3GPP TSG_CN#6
ETSI SMG3 Plenary Meeting #6,
Nice, France
13th – 15th December 1999

NP-99445

Agenda item: 5.1.3
Source: TSG_N WG1
Title: CRs on Work Item GSM-UMTS interworking

This document contains “20” CRs agreed by **TSG_N WG1** and forwarded to **TSG_N Plenary meeting #6** for approval.

Figure 2.1c/24.011: Protocol hierarchy for packet switched service in UMTS

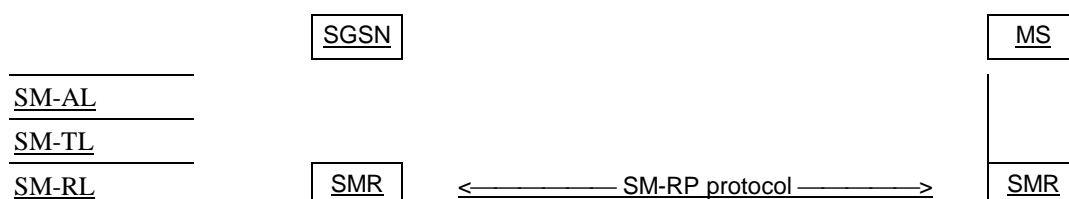
Reason for change: In GSM, LLC is used for PS-SMS message transfer. However, It is agreed that the GMM shall be used for PS-SMS transfer in UMTS system which is described in TS 23.121.

This CR proposes the new SMC-GP functionality that uses GMM to transfer SMS messages for 3G PS-SMS and mainly introduces new information flows for UMTS PS-SMS message transfer and modification of SMC-GP SDL in order to adopt both GSM packet data and UMTS packet data.

The hierarchical model in Figure 2.1b shows the layer structure of the SGSN and the MS in GSM. The hierarchical model in Figure 2.1c shows the layer structure of the SGSN and the MS in UMTS.

Figure X/24.011: GSMS entity for CS/PS mode of operation MS in UMTS

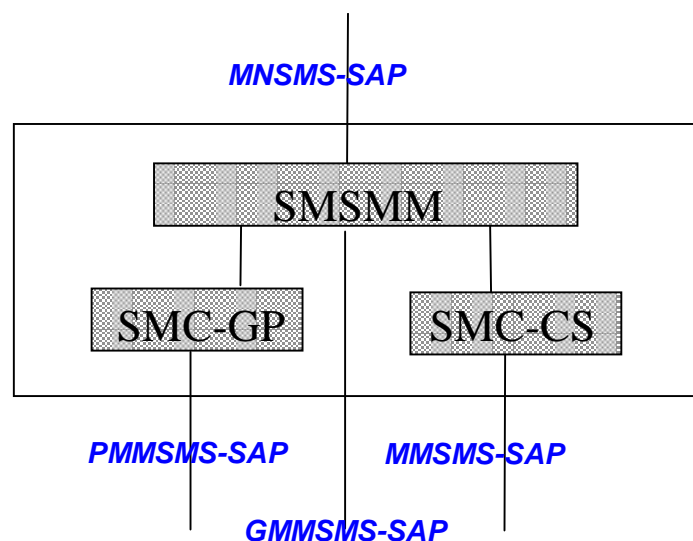
The GSMS entity for CS/PS mode of operation MS is shown in Figure X. The GSMS shall communicate with the MM entity via the GMMSMS-SAP for UMTS CS/PS mode of operation MO SMS, in order to ascertain which transport service to use.

The delivery path for MO SMS is selected by the MS.

GPRS Mobile Originated Messaging on CM-sublayer in UMTS

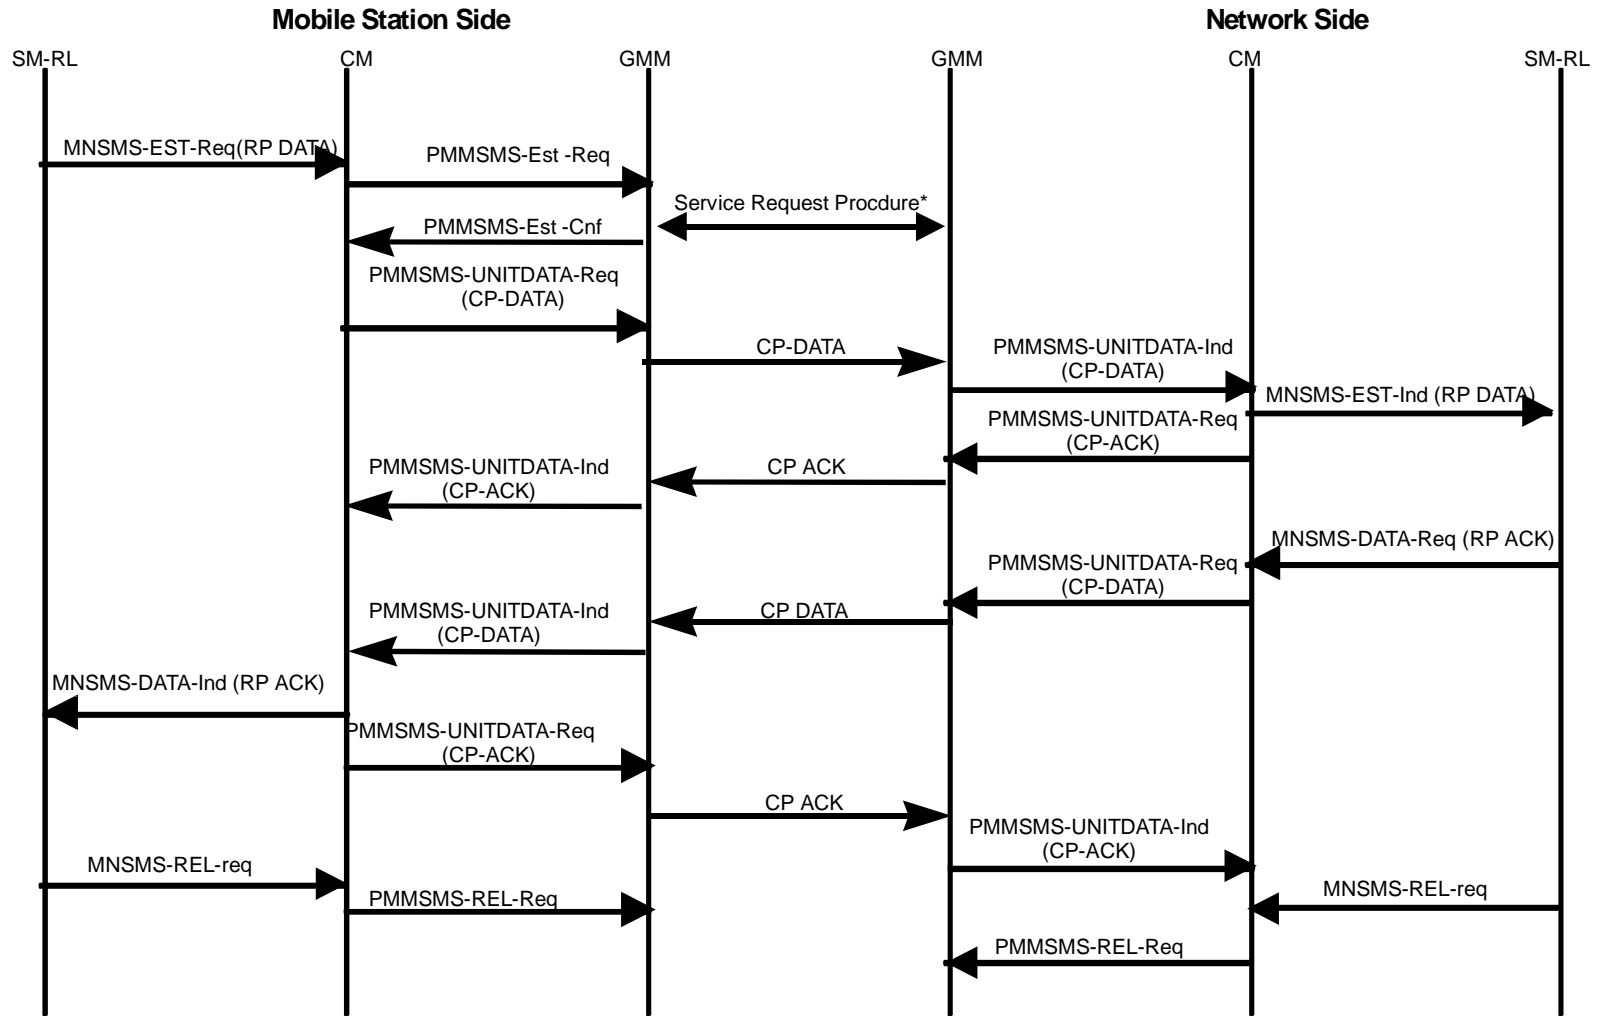
Note: Service Request Procedure may not be initiated.

**MT-SMC-GP entity on MS-side for GPRS
SDL-16**

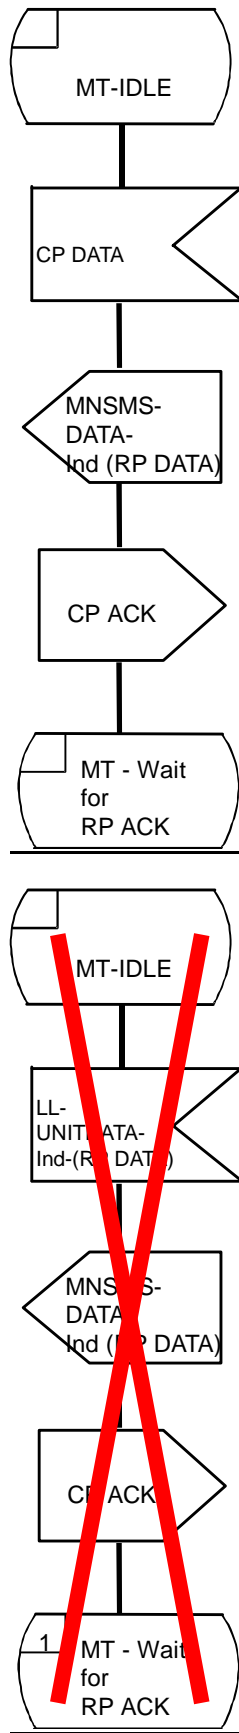
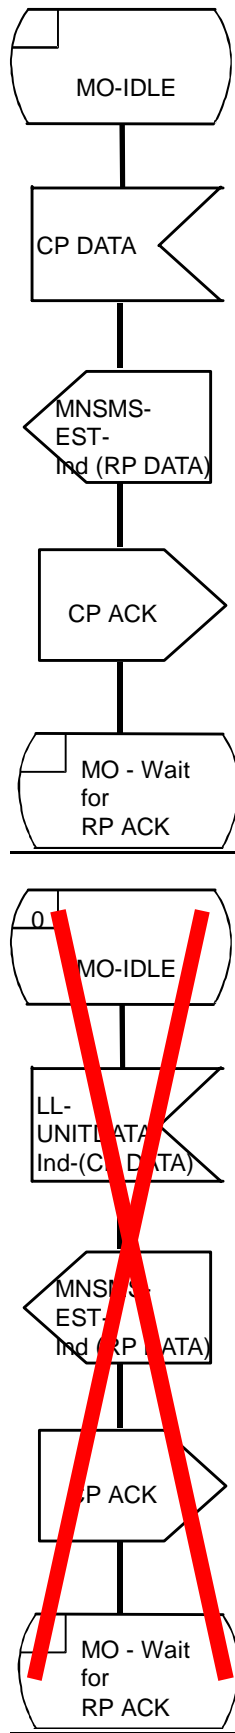
******* Only the modified figures are shown below.*******

Figure 5.5. Protocol architecture of Non Access Stratum supporting PS mode of operation MSs, MS – side

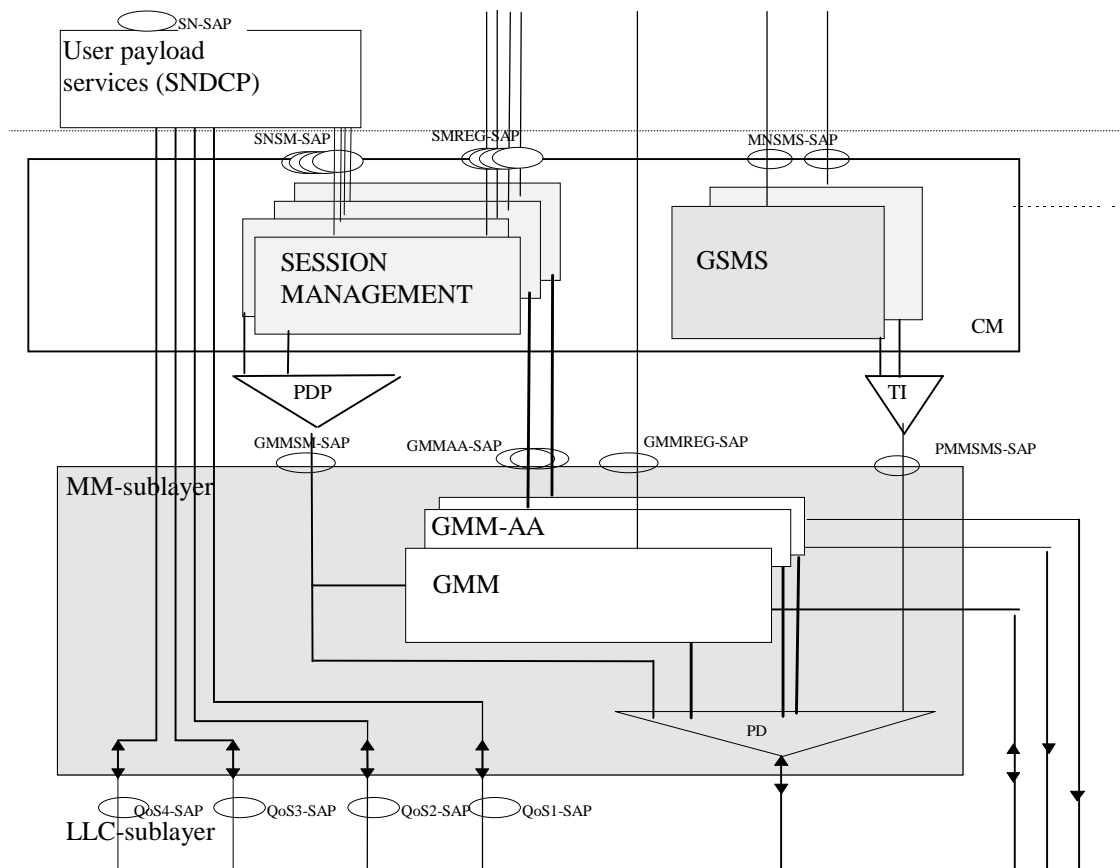
Note: SMS un-related parts of this figure e.g. SNDP and GMM-AA should be modified for UMTS.

Figure 5.6/ 24.007, Protocol architecture of Non Access Stratum supporting CS/PS mode of operation MSs, MS – side

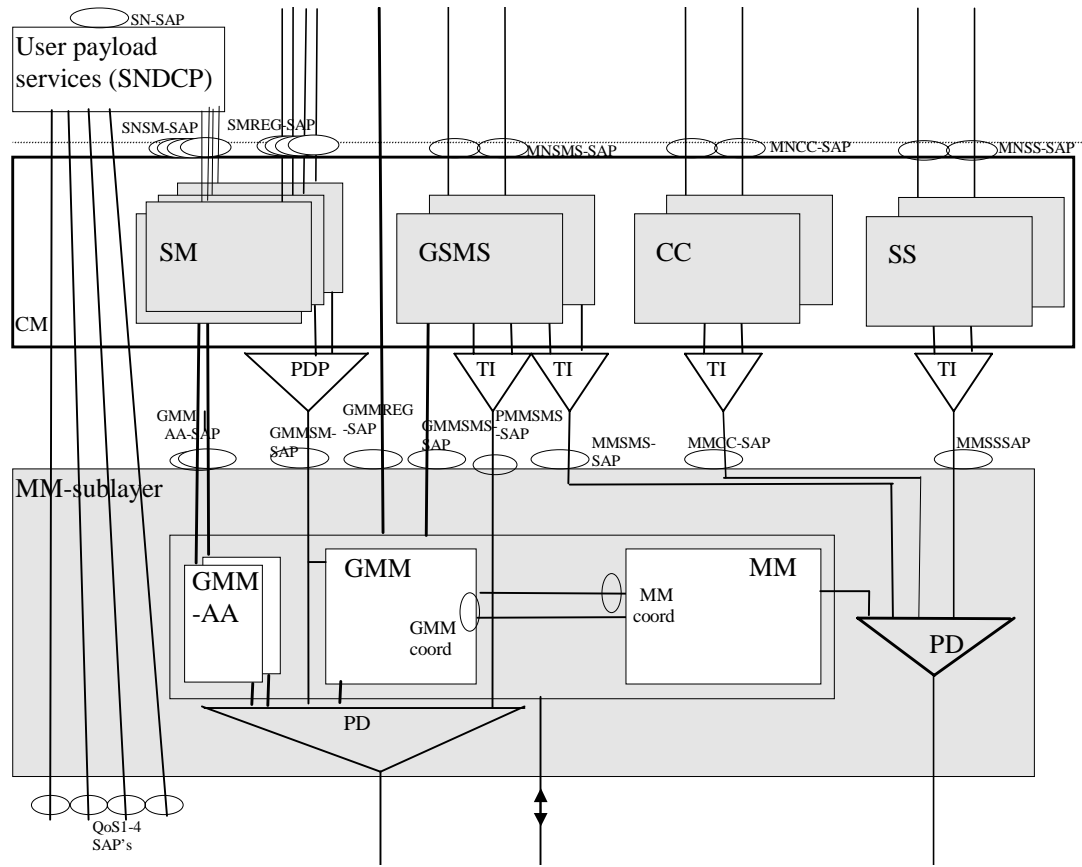
Note: SMS un-related parts of this figure, e.g. SNDP and GMM-AA should be modified for UMTS.

Figure 4.1a / TS 24.008: Overview mobility management protocol / MS Side

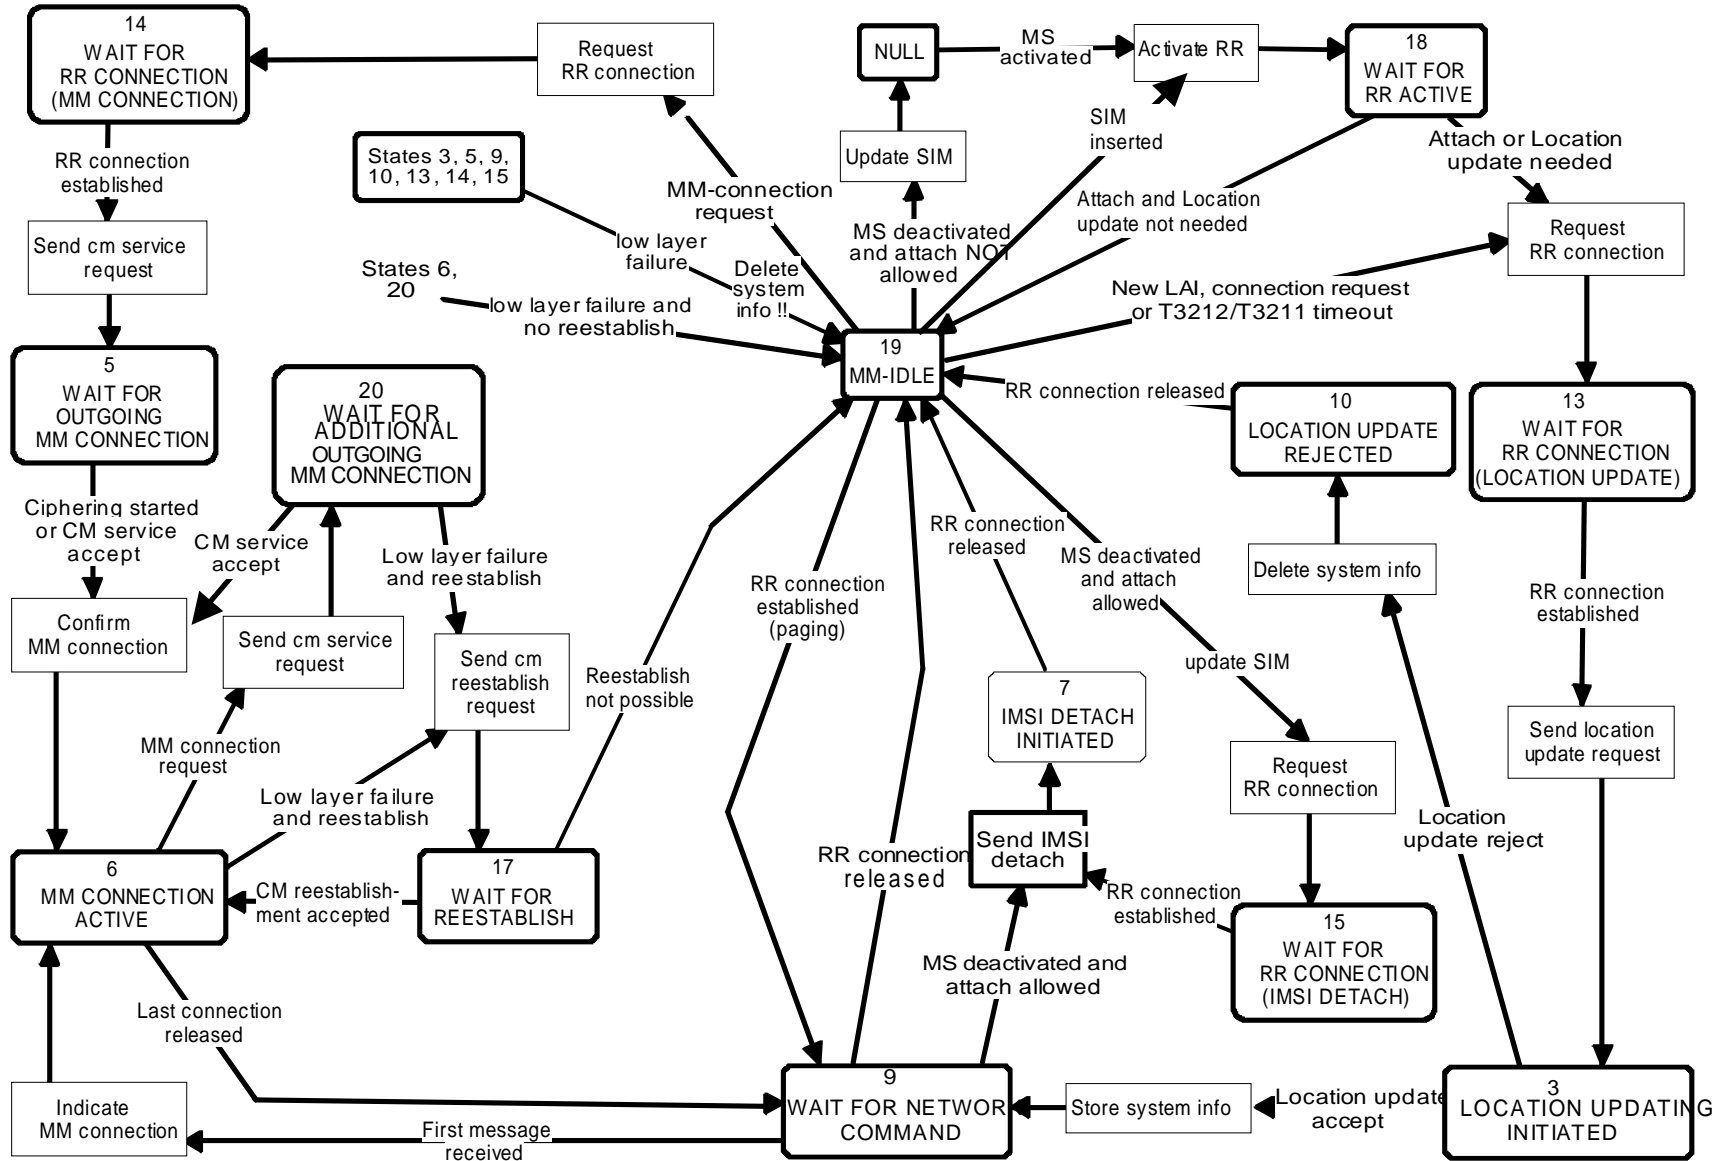
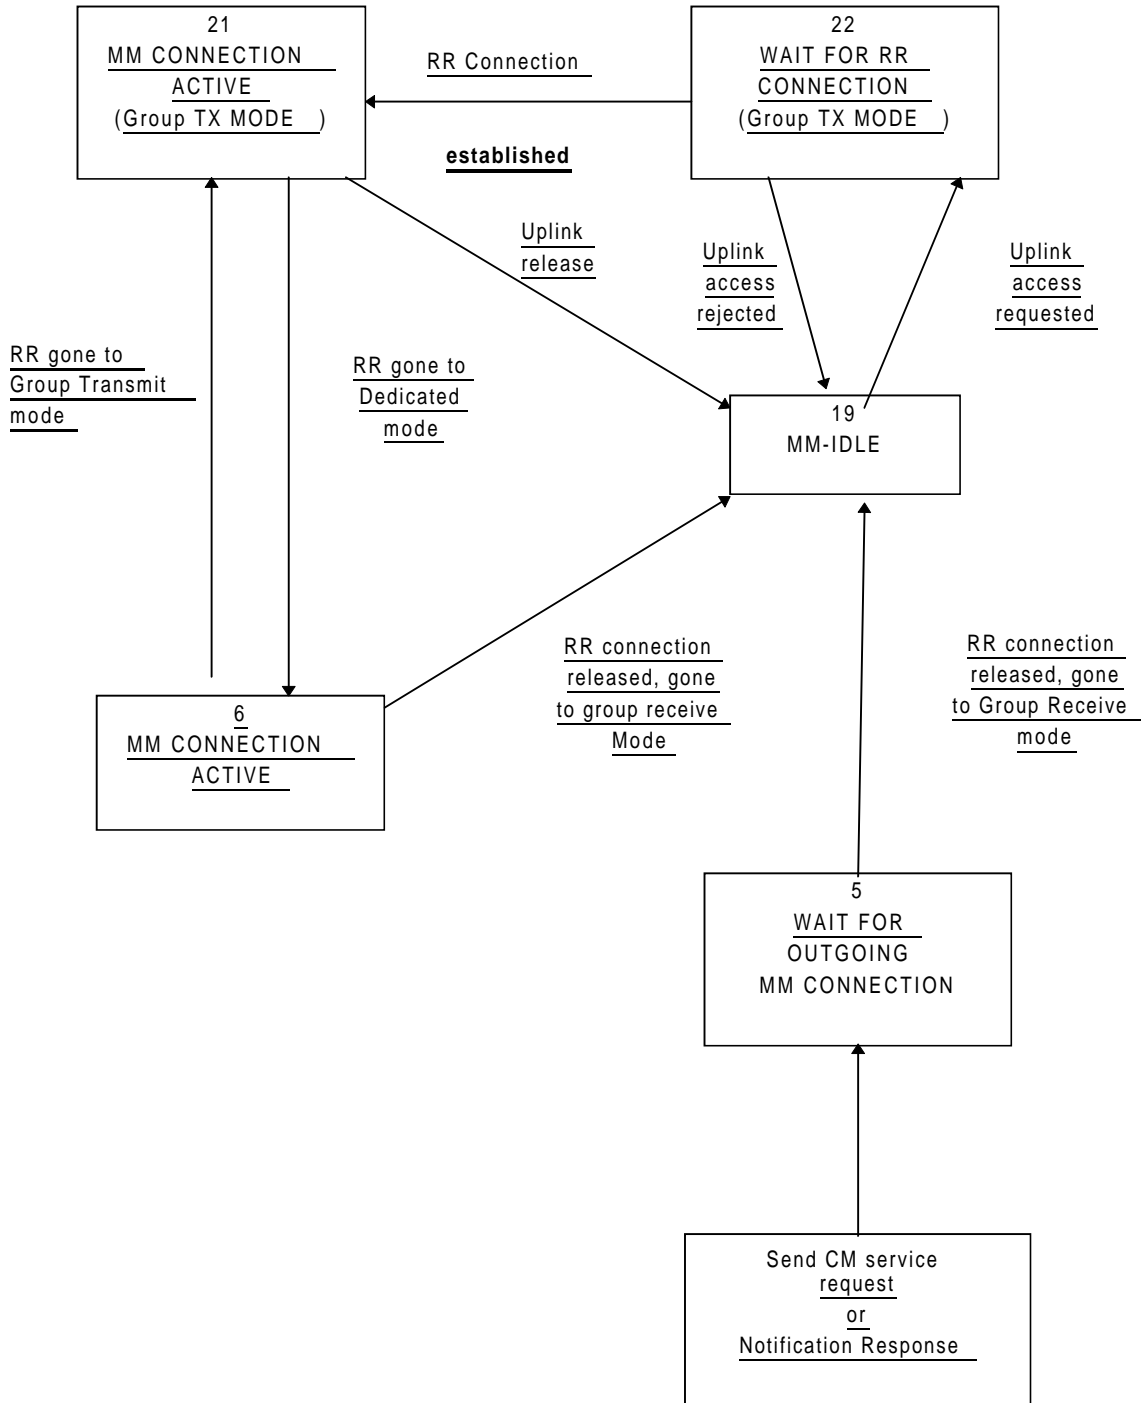
Additions to Figure 4.1.a/TS 24.008

Figure 6.1/TS 24.008: Session management states in the MS (overview)

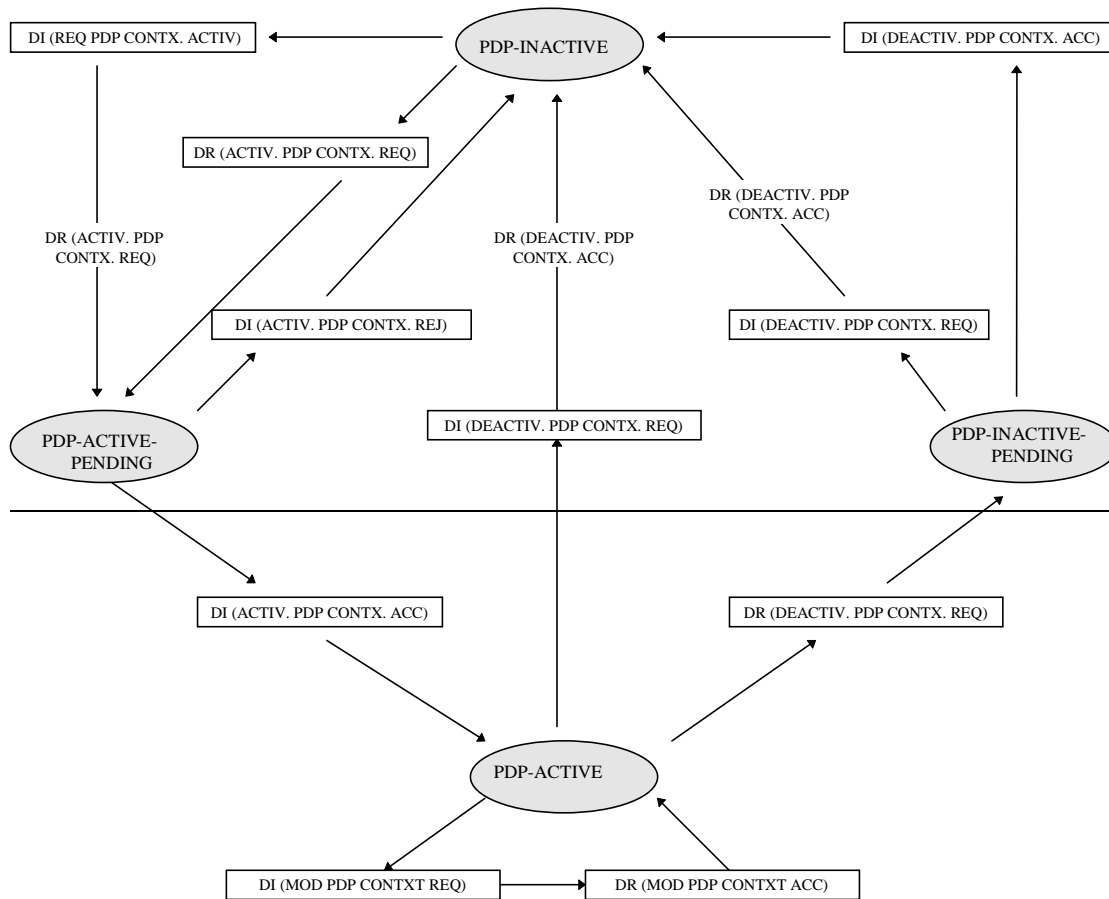
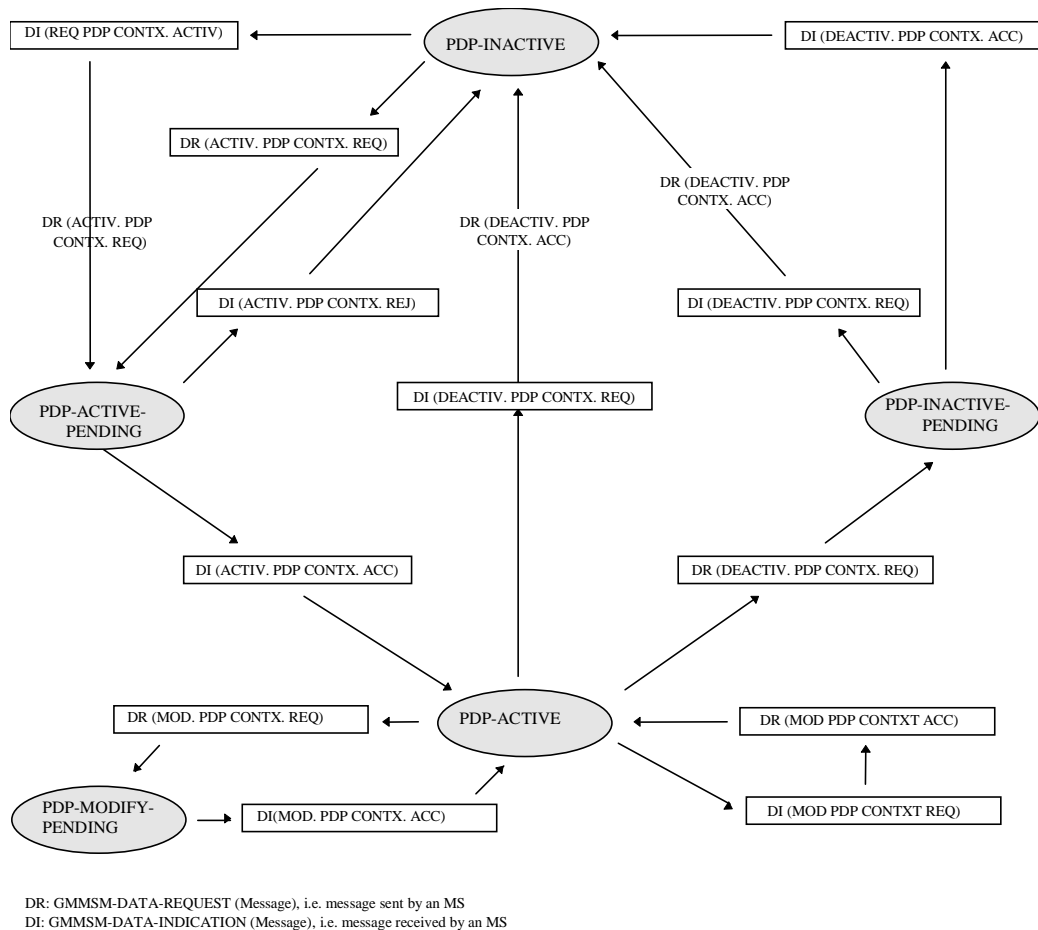
In this section, the possible states of an SM entity in the mobile station are described. As illustrated in figure 6.1/TS 24.008 there are ~~four~~ five SM states in the MS.

It shall be noted, that Figure 6.1/TS 24.008 applies to both primary and secondary PDP contexts, though the distinction in messages regarding the activation of primary and secondary PDP contexts is not shown here for simplicity.
